MISSION TRAILS

DESIGN DISTRICT ORDINANCE AND DESIGN MANUAL

SAN DIEGO RIVER PARK MASTER PLAN
PROPOSED AMENDMENTS
PTS 121886
May 2013

ATTACHMENT 10 San Diego River Park Master Plan Proposed
Amendments - May 2013

Diagram 1
Section and Plan View of River Corridor Area and River Influence Area

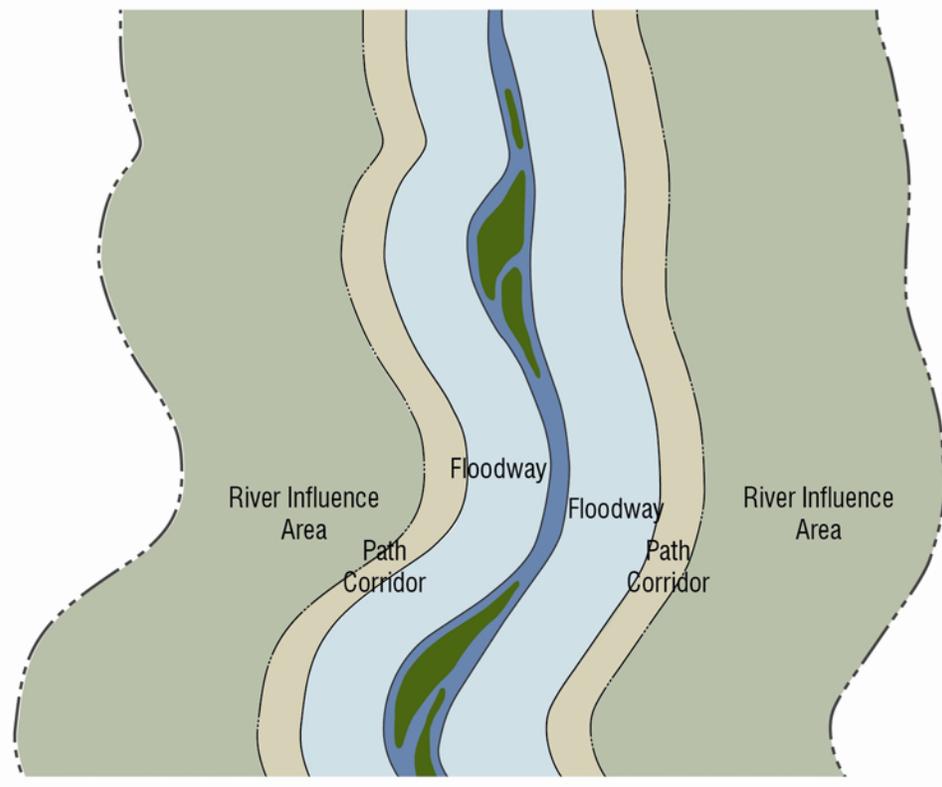
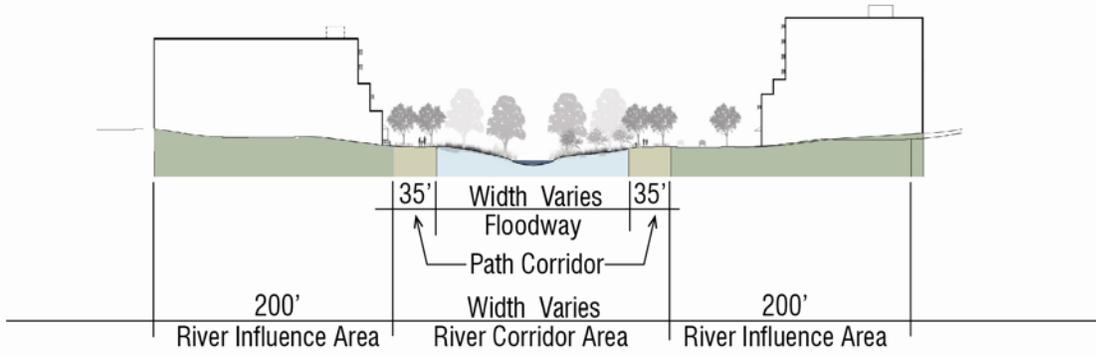
The San Diego River Park Subdistrict includes the River Corridor Area and the River Influence Area. The River Corridor Area comprised of the current 100-year floodway (floodway) as mapped by Federal Emergency Management Agency (FEMA) and the 35-foot wide Path Corridor on each side of the floodway. The River Influence Area is the 200-foot wide area extending outward from the River Corridor Area on each side of the river, as illustrated in Diagram 1.

Diagram 2
Path Corridor Realignment for MHPA and Wetland Buffer

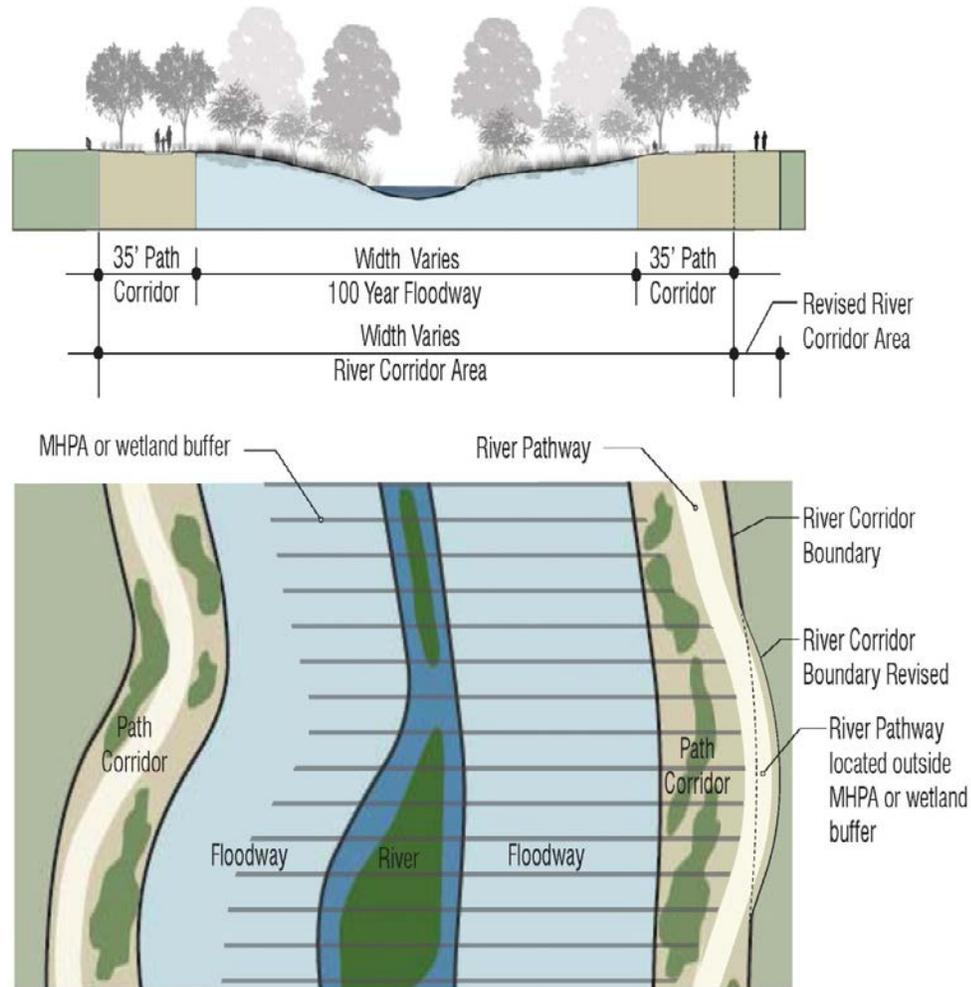
Where portions of the Path Corridor are mapped as MHPA, as identified by the City of San Diego MSCP Subarea Plan, or determined to be wetland buffers in accordance with Land Development Code Section 143.0141, the River Pathway shall be located outside the MHPA and the wetland buffer, immediately adjacent to the Path Corridor. See Diagram 2, Path Corridor Realignment for MHPA and Wetland Buffer.

Diagram 3

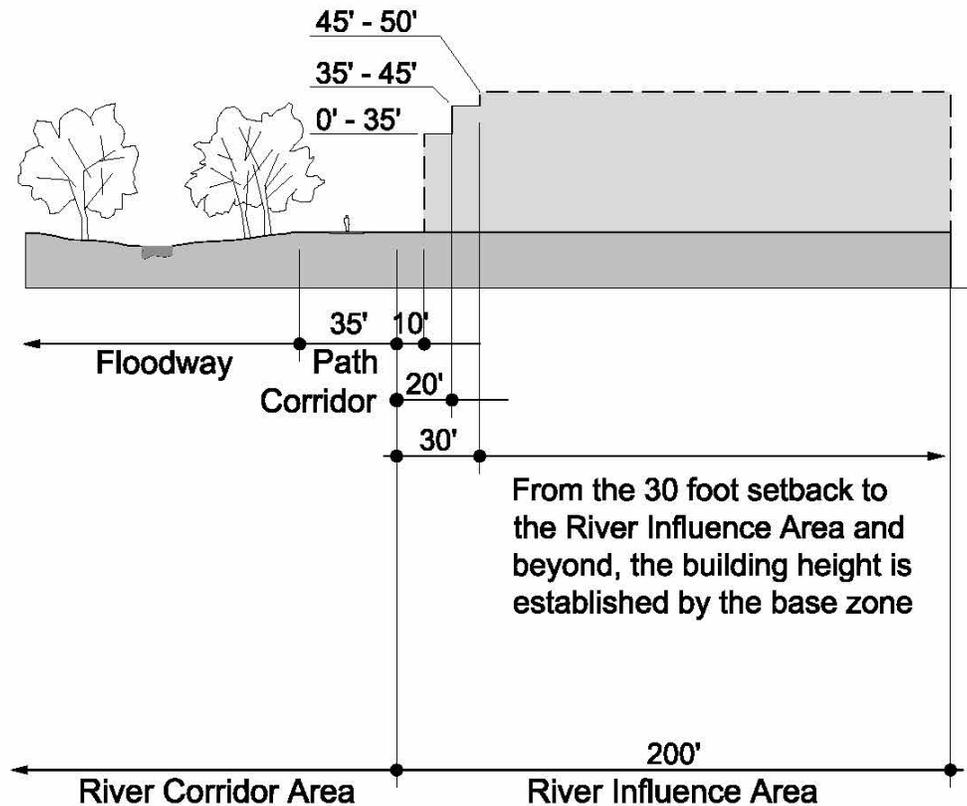
(a) Buildings Height and Setback on Lots Adjacent to the River Corridor Area: Building height and setbacks on lots adjacent to the River Corridor Area, and shall be compliance with Table 1 or the base zone, whichever is more restrictive, and as illustrated in Diagram 3.
